Upper Occoquan Service Authority

For UOSA IFB 21-18, Roof Replacement Services

SUBJECT: Addendum #1

DESCRIPTION OF ADDENDUM:

L. Roofhatch Guardrail with Gate

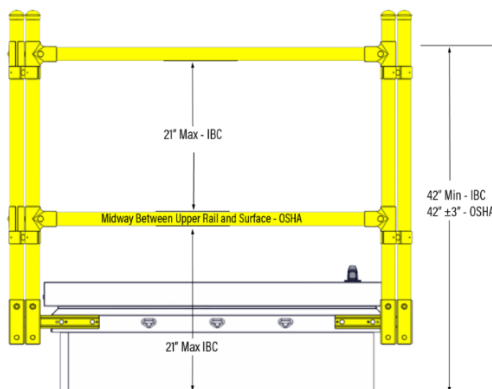
1. The addition of a safety railing around existing roof hatch has been added. Paragraph 1.2 PROJECT SUMMARY is deleted in its entirety and replaced with Attachment A to this Addendum.
2. Paragraph 1.15 is changed to read “Bidder shall include a schedule that assume a start date of September 1 and provides number of days required to complete each principal task area. Do not factor in bad weather days.

1. Guardrail with gate shall be constructed in accordance with OSHA 1910 and IBC 1015 as shown below:

The top edge height of top rails, or equivalent guardrail system members, are 42 inches (1.07 m), plus or minus 3 inches (8 cm), above the walking/working surface. The top edge height may exceed 45 inches (1.14 m), provided the guardrail system meets all other criteria of paragraph (b) of this section.

Midrails are installed at a height midway between the top edge of the guardrail system and the walking working surface.
